SUBSURFACE WASTEWATER DISPOSAL SYSTEM APPLICATION

PROPERTY LOCATION		>> Caution: Permit Required – Attach in Space Below <<
City, Town, or Plantation	Augusta	
Street or Road	1107 Tasker Road	
Subdivision, Lot #

REPLACEMENT SYSTEM VARIANCE REQUEST

Subject: Approval, Replacement System Variance Request, Doyon Property, 1107 Tasker Road, Augusta, Maine, 04330. Mailing Address Of: Philip Doyon, 1105 Tasker Road, Augusta, Maine, 04330.

SHEET TITLE: PLAN VIEW

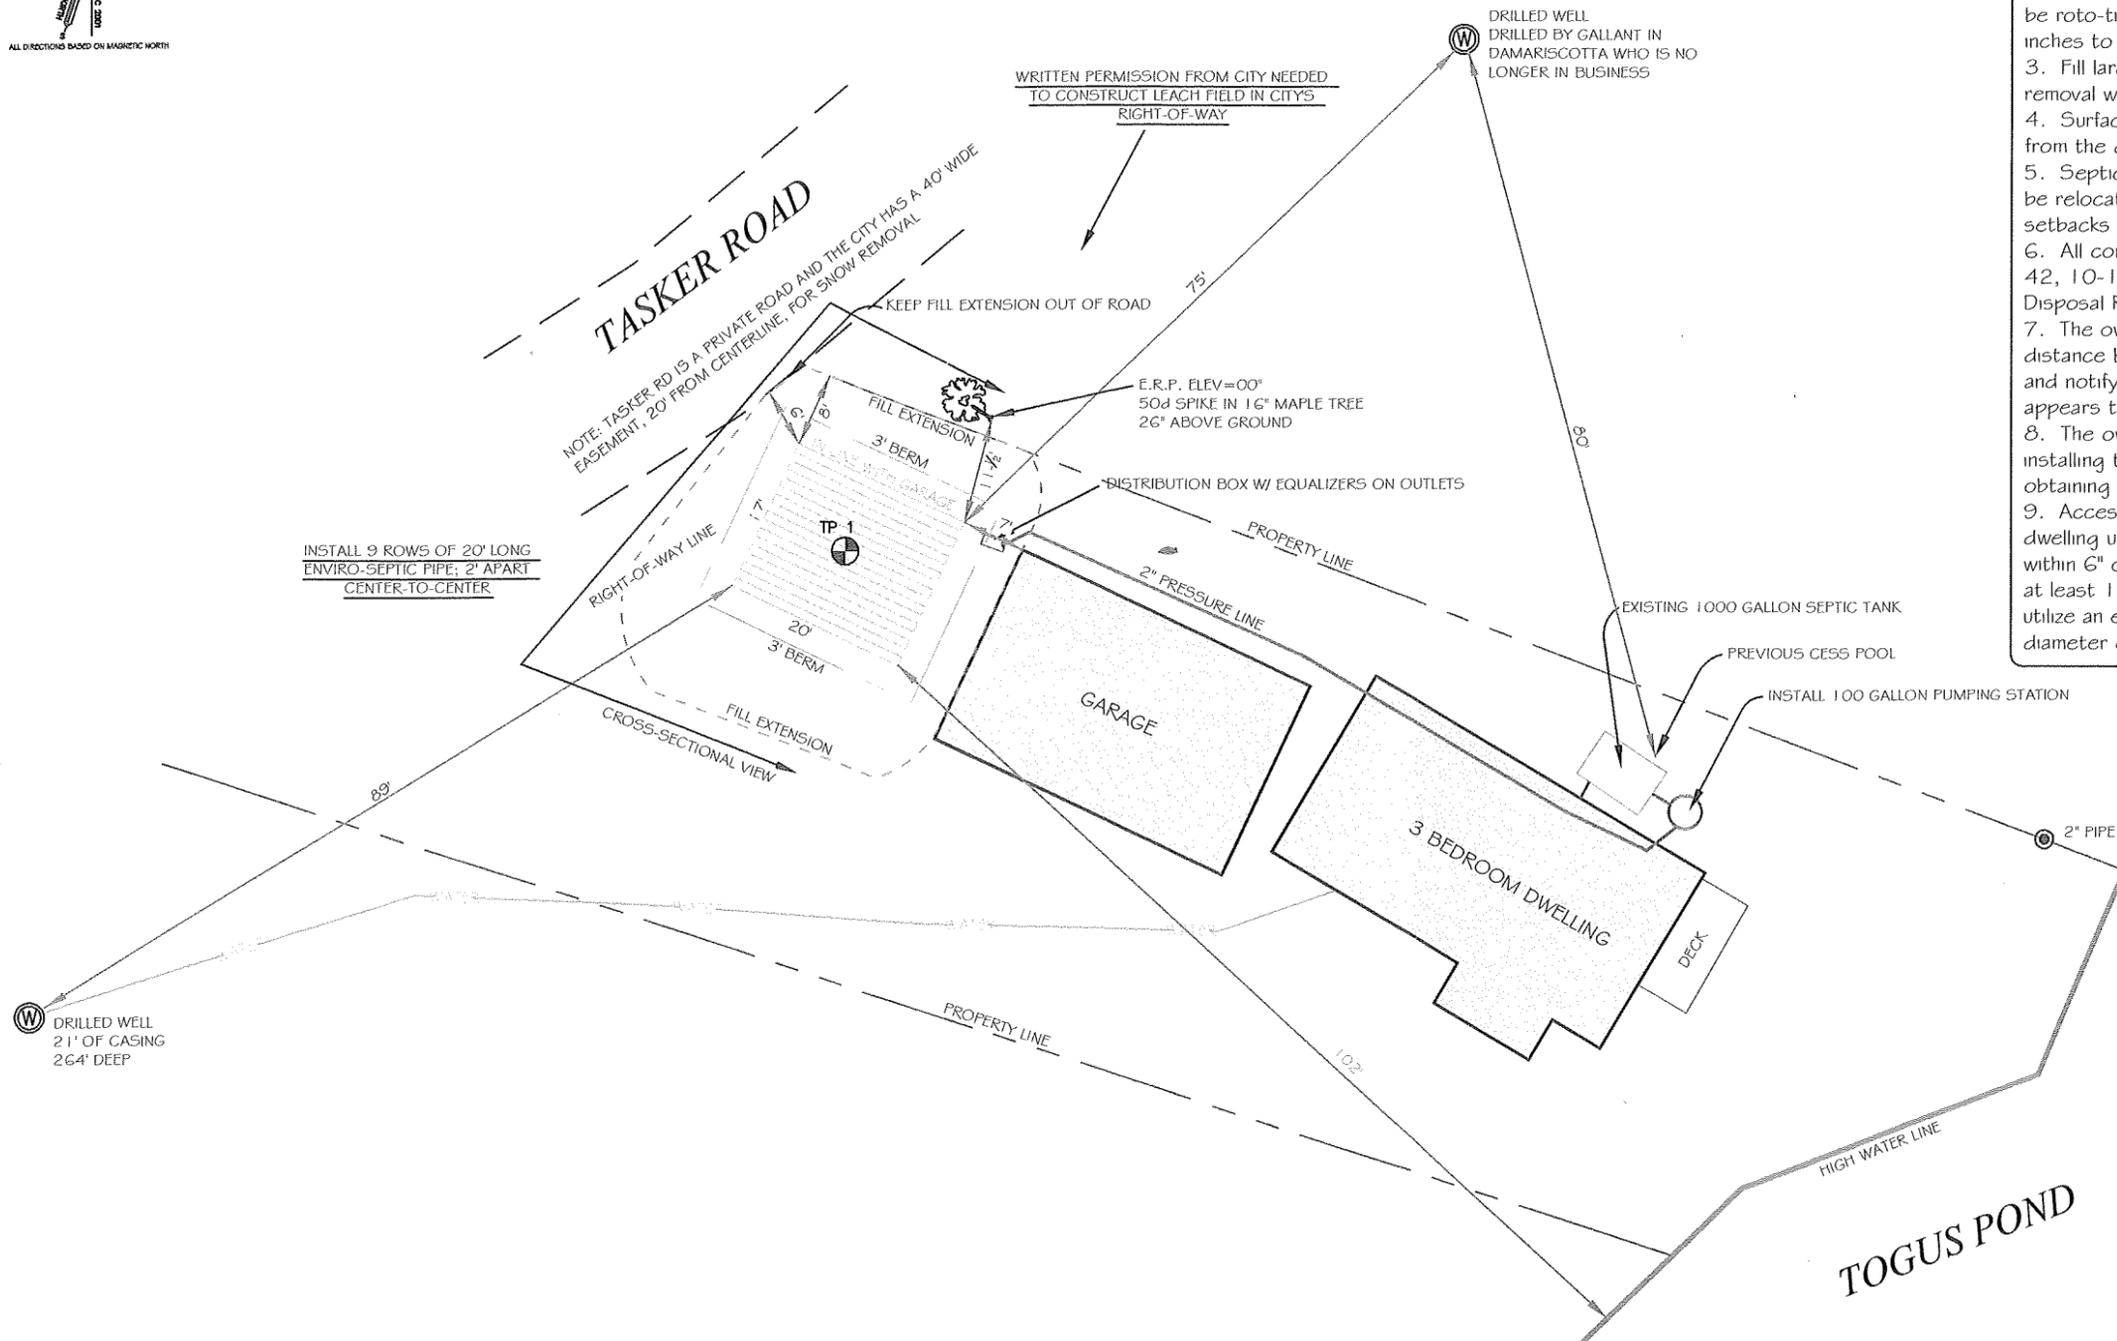
The proposed leach field (9 rows of 20 feet long Enviro-Septic Pipe, spaced 2 feet apart) is within the 40-foot wide snow plow easement the City of Augusta has along Tasker Road. The site chosen for the leachfield is in the best and only location for the site limitations on this parcel.

Please submit a request to the City Council, in reference to Philip Doyon's replacement septic system, for obtaining approval to impact the 40-foot wide snow plow easement (20 feet from the centerline of the existing travel way) for the installation, operation, and maintenance of a leach field as shown on the attached subsurface wastewater disposal plan. We acknowledge the city will not be liable for damages caused to the leach field from snow plowing.

The City has no objection with the construction, operation, replacement, and maintenance of the system as submitted .

SHEET TITLE: PLAN VIEW
 SCALE: 1" = 20'
 DATE: JULY 21, 2010

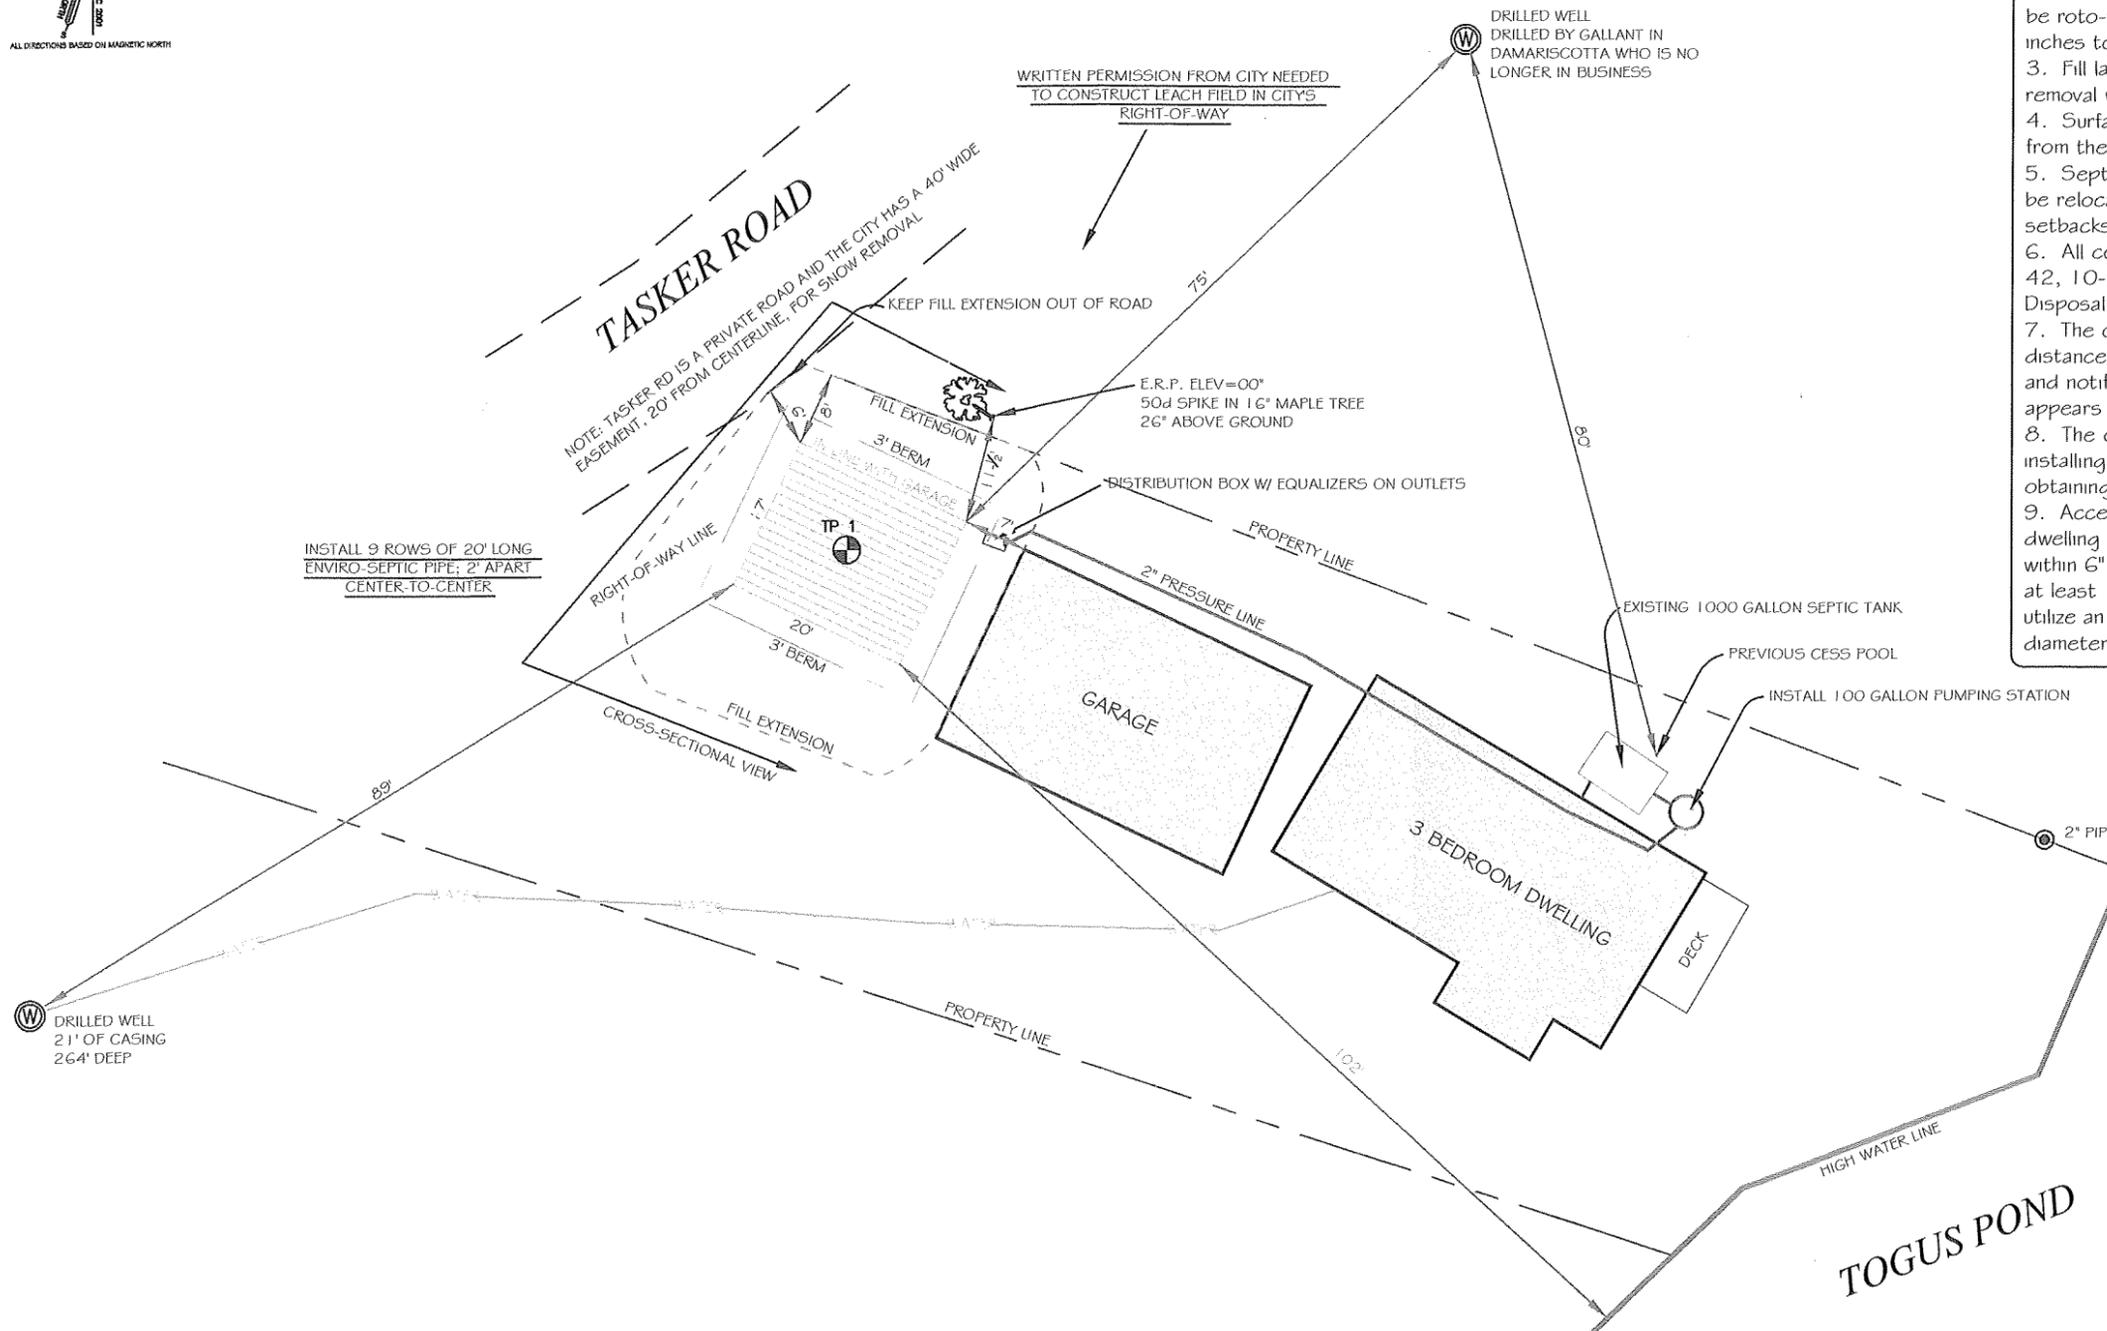
The variance requested which is not within the LPI's authority is from a potable water supply to the disposal field of 75 feet and to another potable water supply to the disposal field of 89 feet in which both setbacks are closer than the existing disposal field.

The variances requested that is within the LPI's authority is from the septic tank to the potable water supply of 80 feet, from the disposal field to the no full basement of 7 feet and from the disposal field to the property line of 6 feet.

We approve the setback distances to both potable water supplies. The potable water supply which has a setback distance of 75 feet is located up hill from the disposal system and the potable water supply with a setback distance of 89 feet is not located directly in line with the down slope of the disposal field and also has an existing compacted driveway between the disposal field and that potable water supply.

A letter of no objection has been issued by the City of Augusta concerning the encroachment of the fill extension into the right of way for Tasker Road.

1. A permit for system installation is to be obtained from the Local Plumbing Inspector in advance of the start of system construction.
2. The system is to be installed in accordance with the submitted and approved system design. Should alterations to the design be required at the time of construction, the site evaluator is to be notified prior to making any changes.

3. The contractor is to scarify the soils under the fill extensions to create a transitional zone more compatible with the disposal field area.
